Anacortes City Council
Municipal Building Council Chambers
904 Sixth Street

6. **Public Hearings**
 - a. * Open Record Public Hearing, SPL-2015-0006, 38th Street Short Plat, Appeal of Administrative Decision (Discussion/Possible Action)

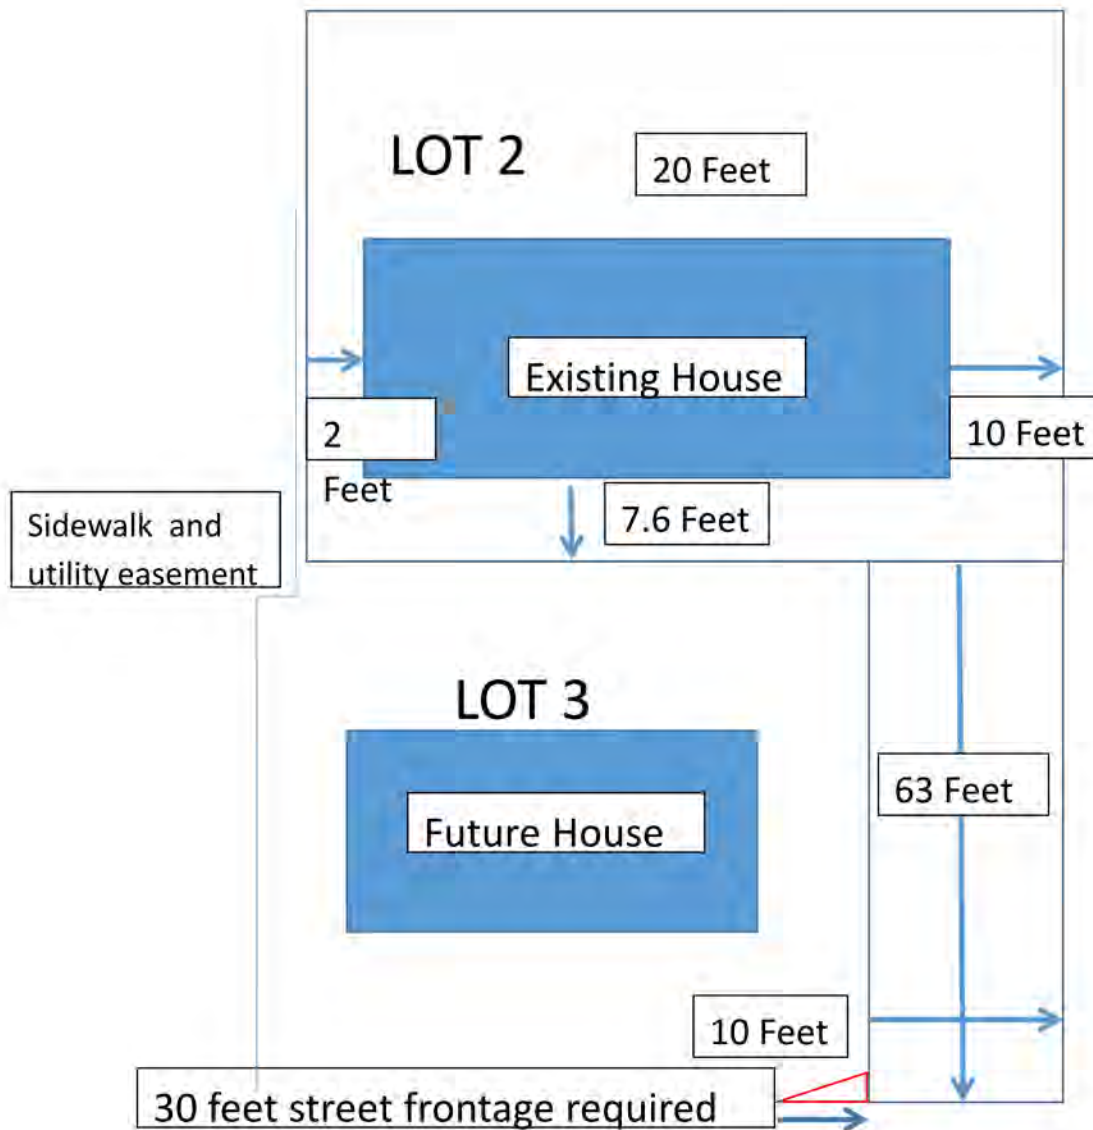
Proposed lot
falls short of
setbacks

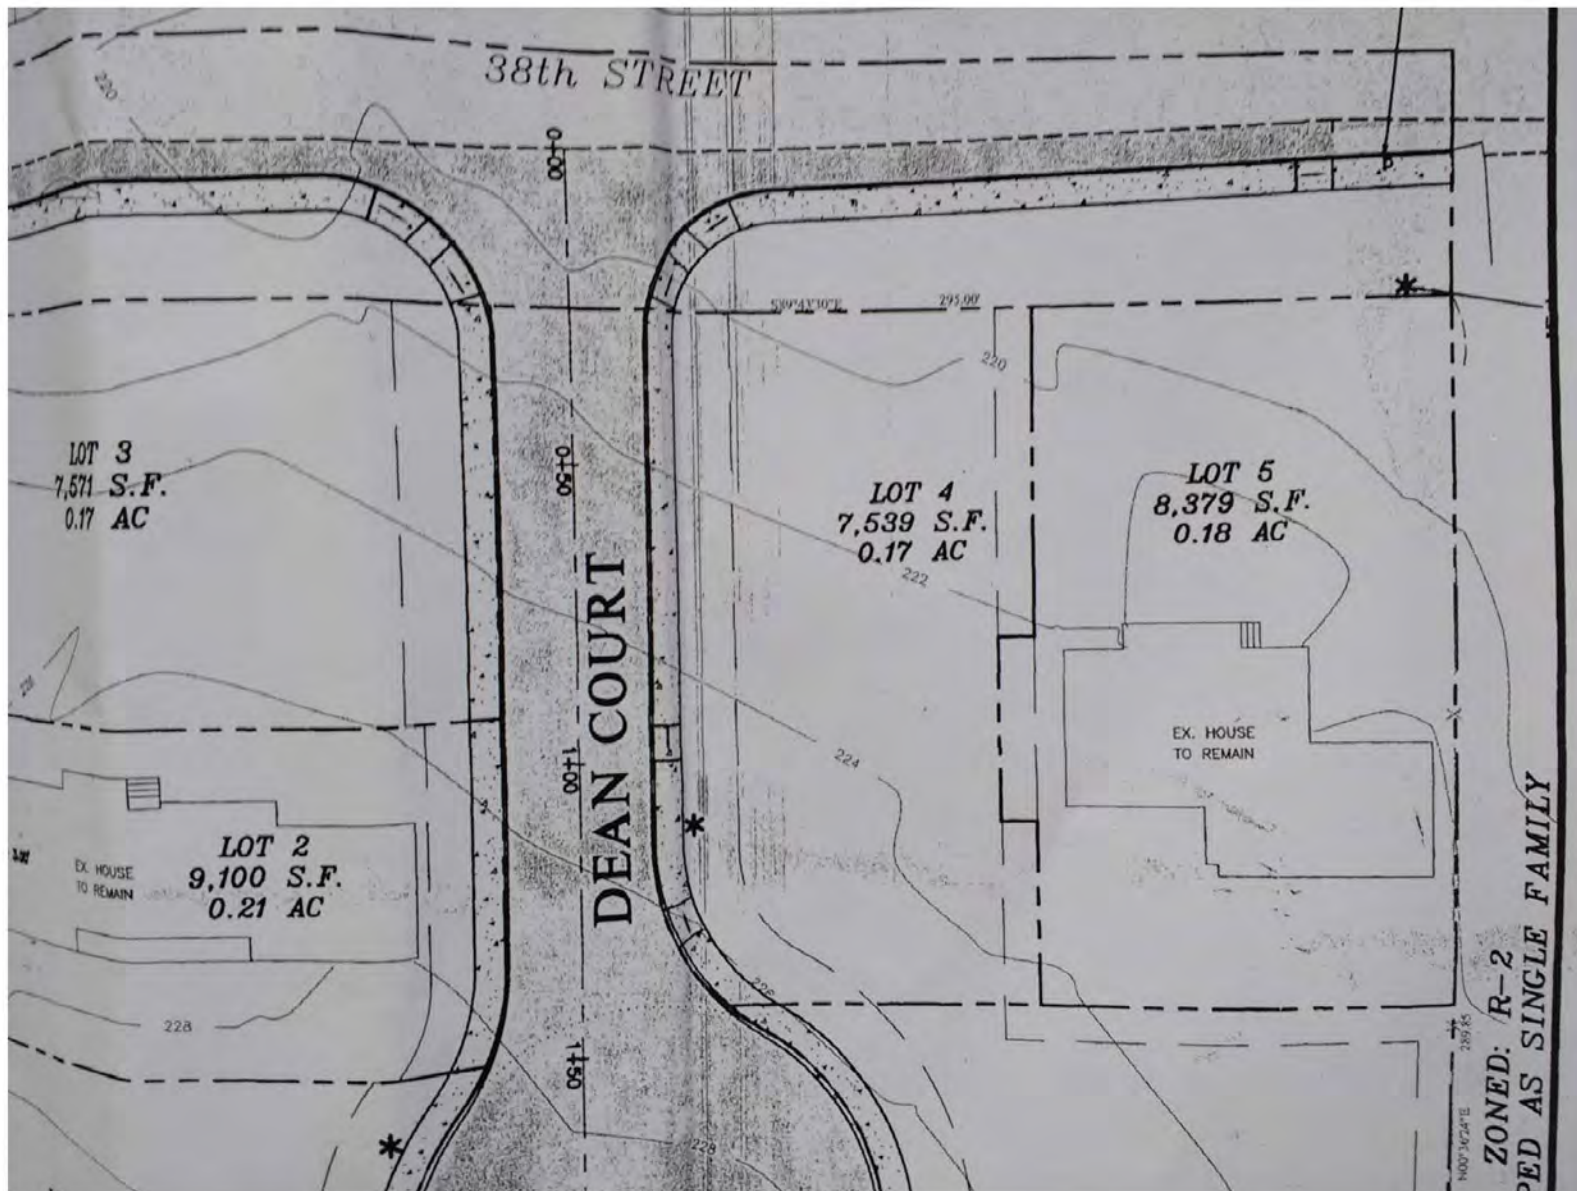
Cul-de-sac sidewalk easement will be 2' from edge of existing house (left side)

K is an undeveloped right-of-way. What is the process for permitting permanent access along this?

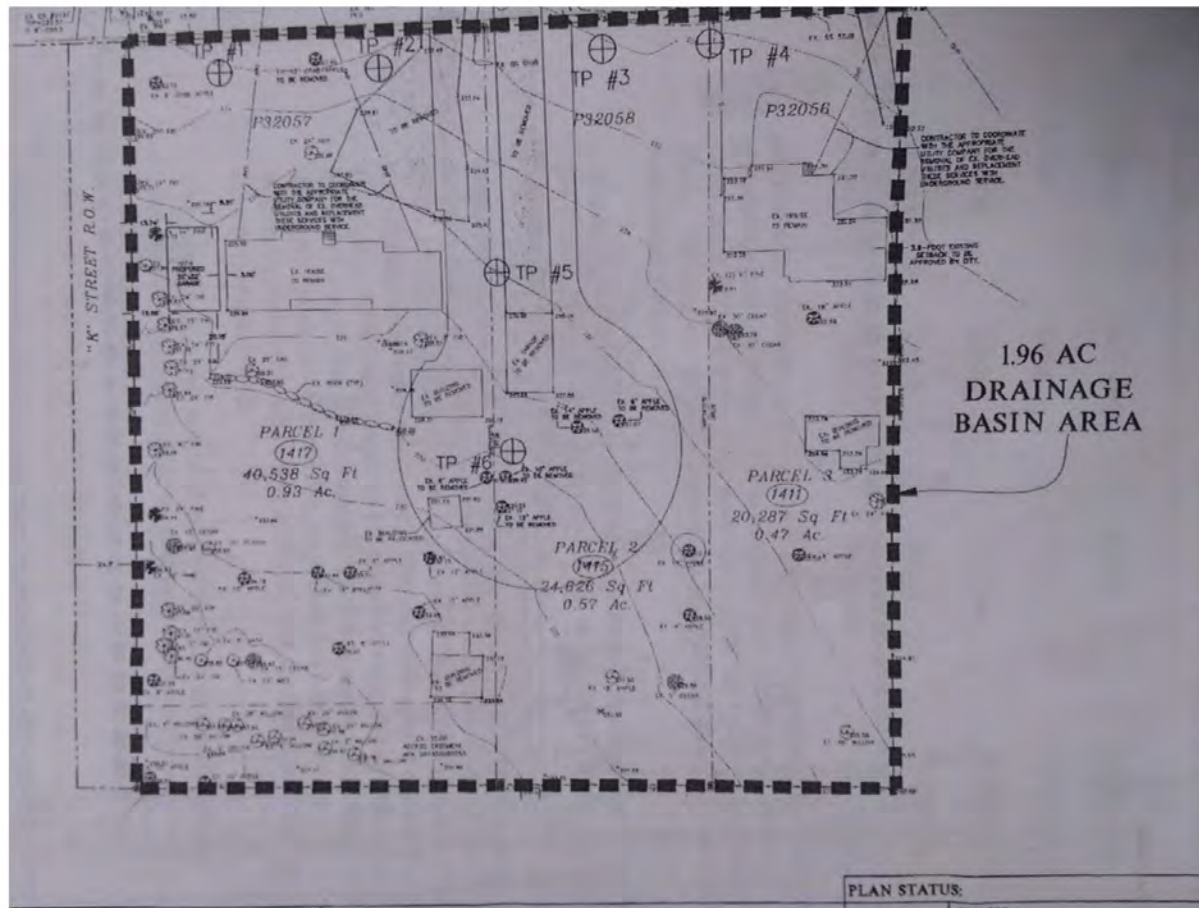
Stormwater Plan must account for volumes of water from the drainage basin.

Ace of Hearts Park area raised up with land fill increasing drainage volume

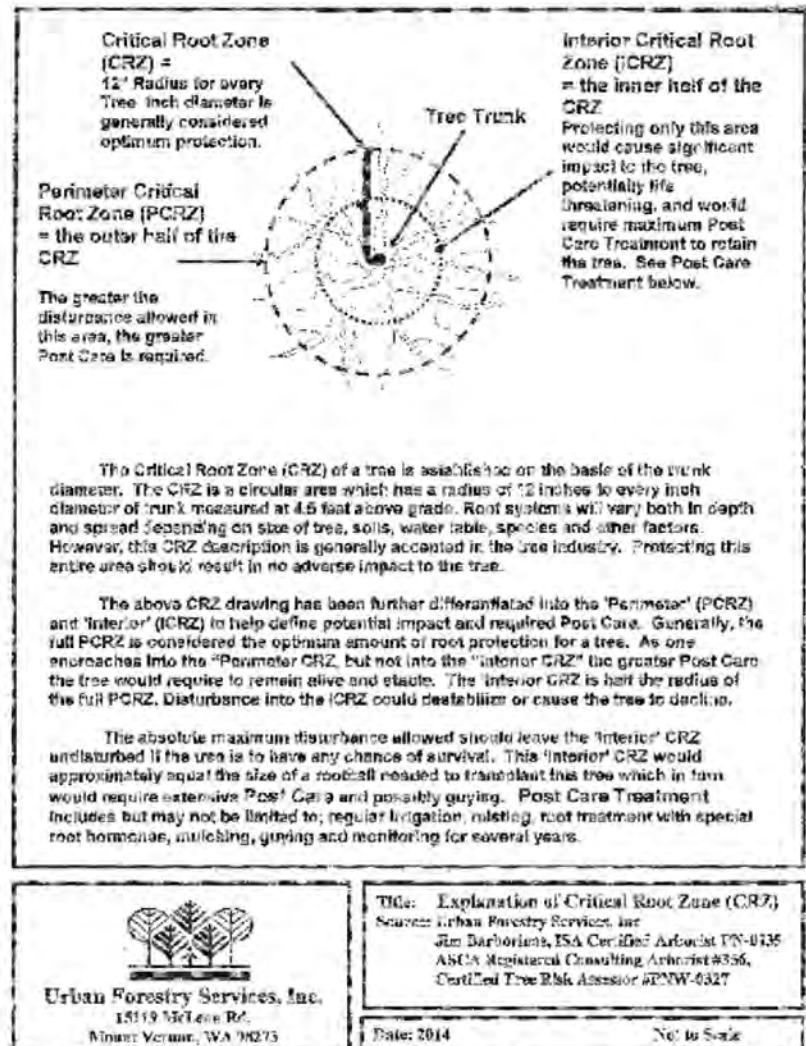
Utilities located within bio-infiltration swale location

Trees cannot be saved when excavating for driveway and paving K Ave.

1 OF 4

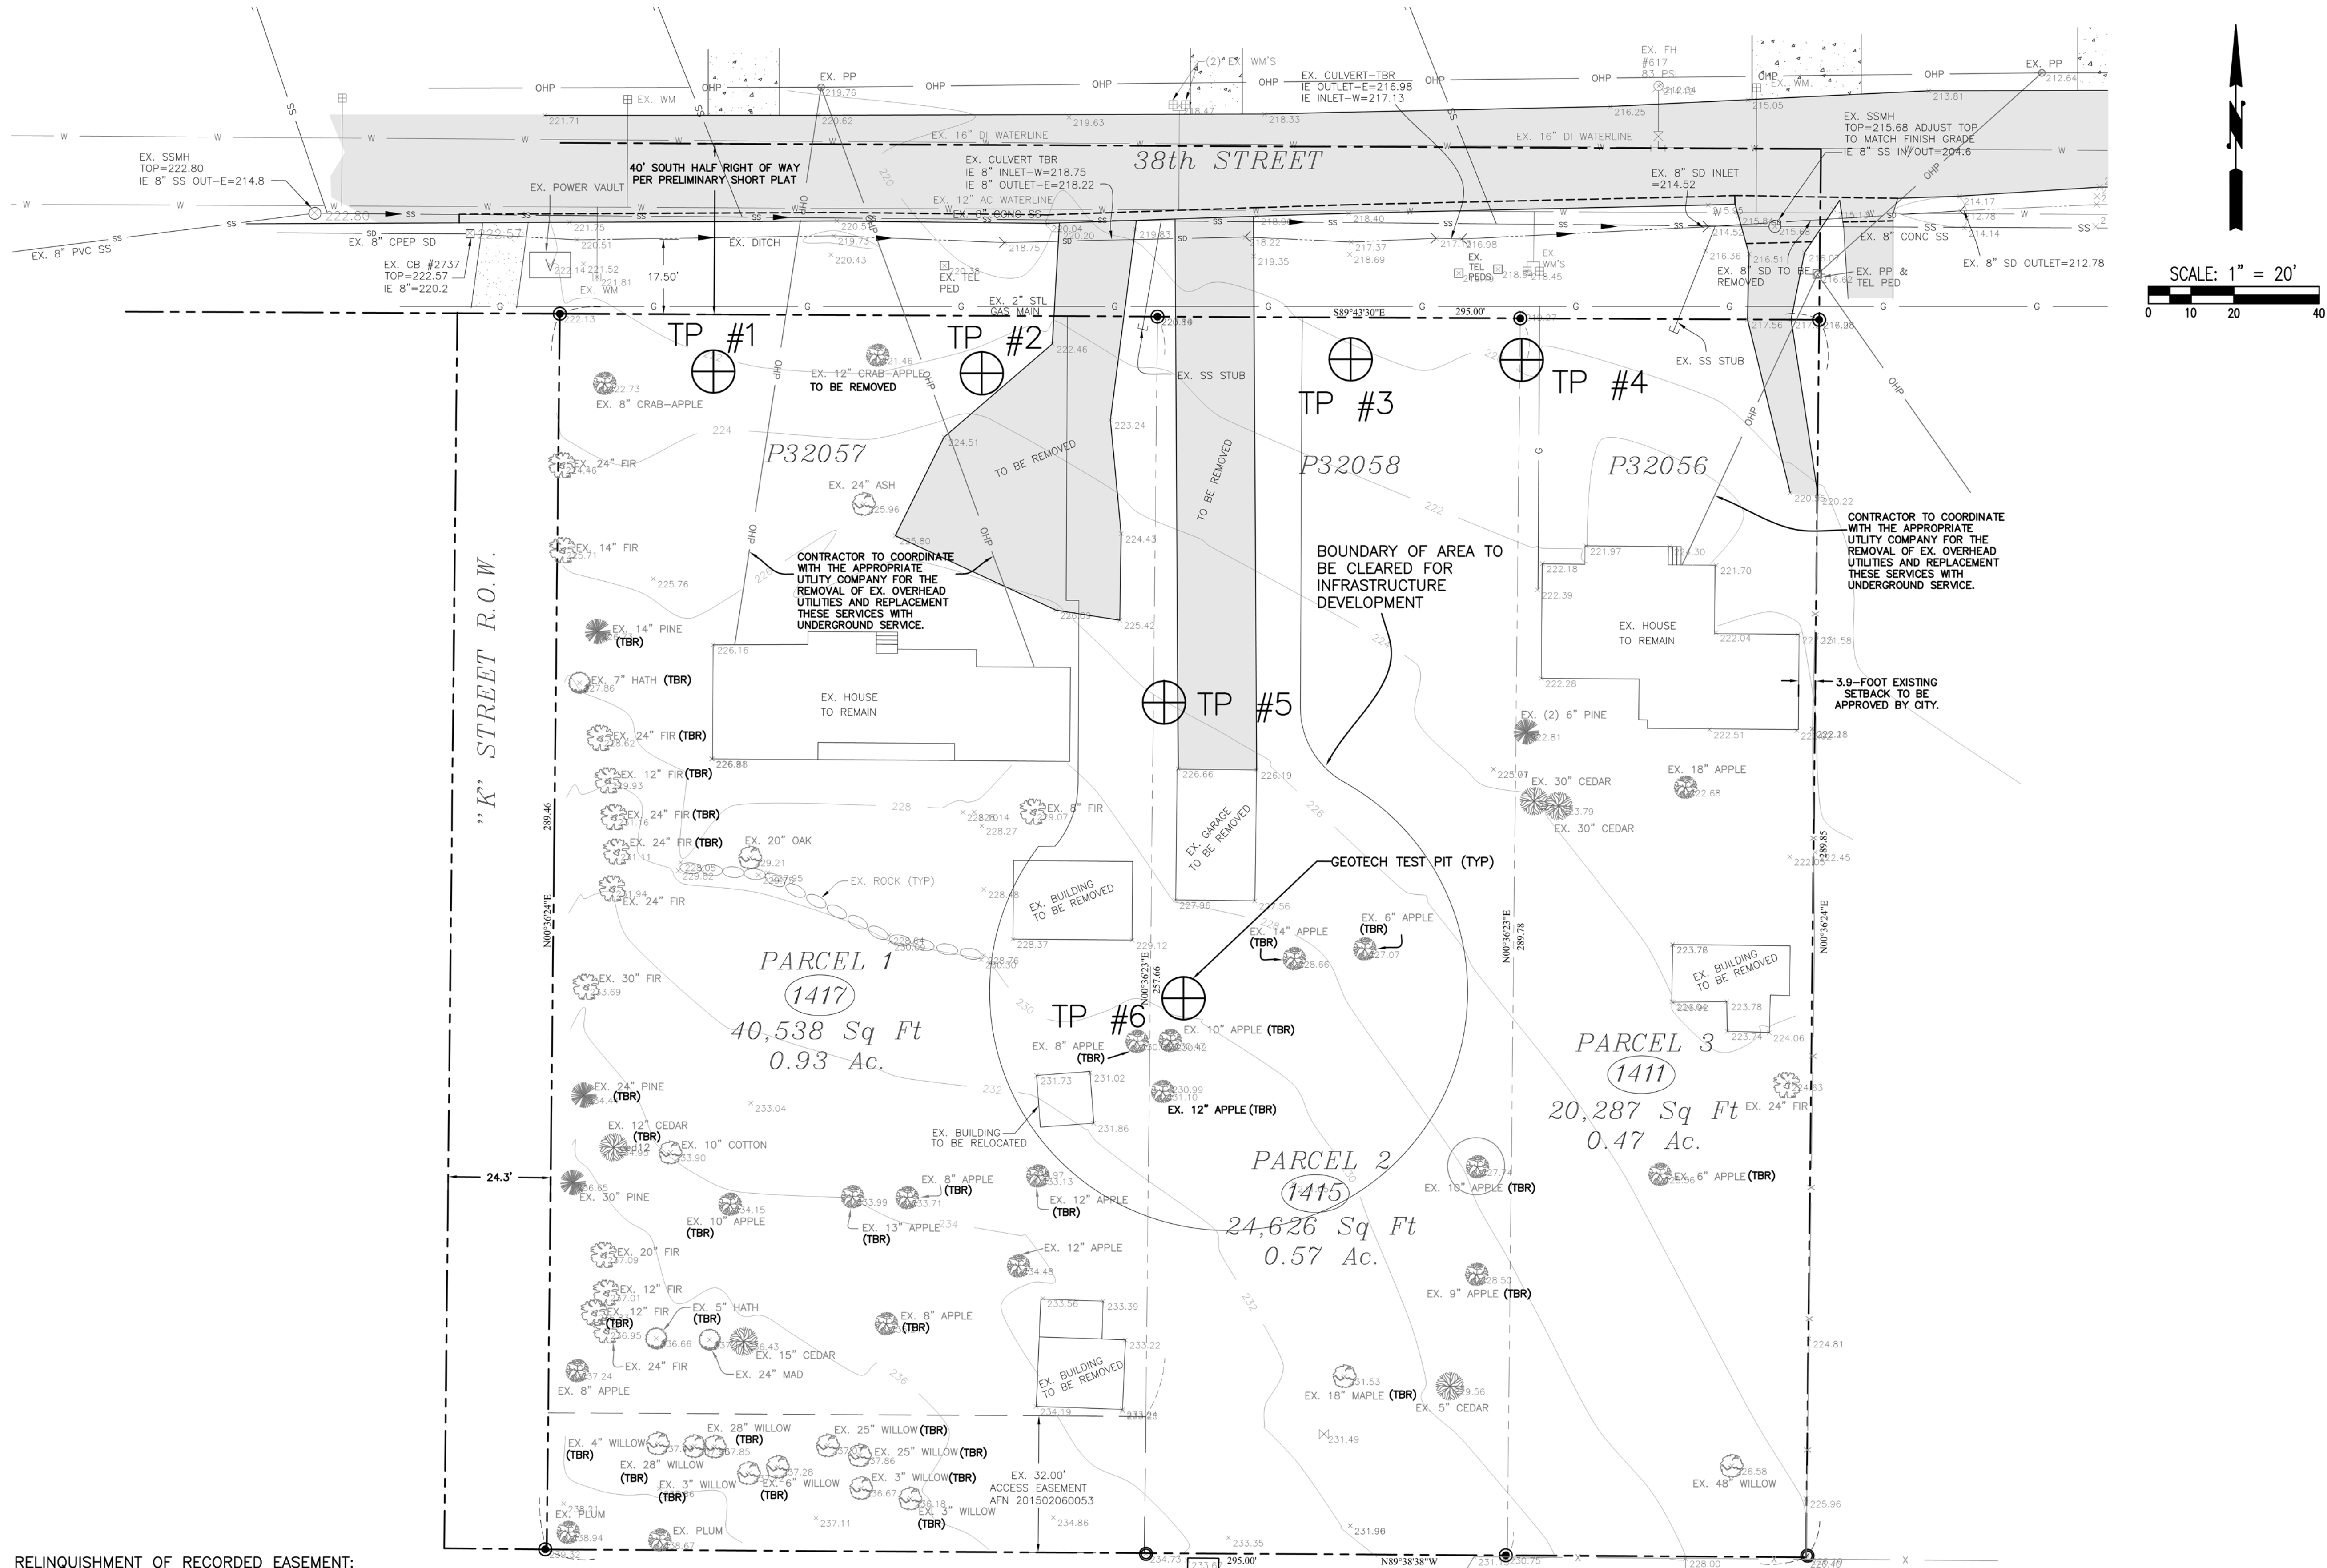
8. On sheet 1 of 2, please include both the net and gross square footage involved in the subject short plat along with your density calculation. Additionally, please show how conformance with the maximum density (4 dwelling units per acre) requirement per AMC 17.36.080 is being met in the R2 Zoning District.

Response: Density calculations are provided on civil sheet 1 provided with this application. For this project, the permissible density is calculated using all of the subject property and one-half of the abutting rights of ways. The lot sizes and project density do conform to the City's R-2 standards.

Response: *This information has been added to sheet 1 of 2 of the Short Plat Map. This information is also located on sheet 1 of the civil plan project exhibits.*
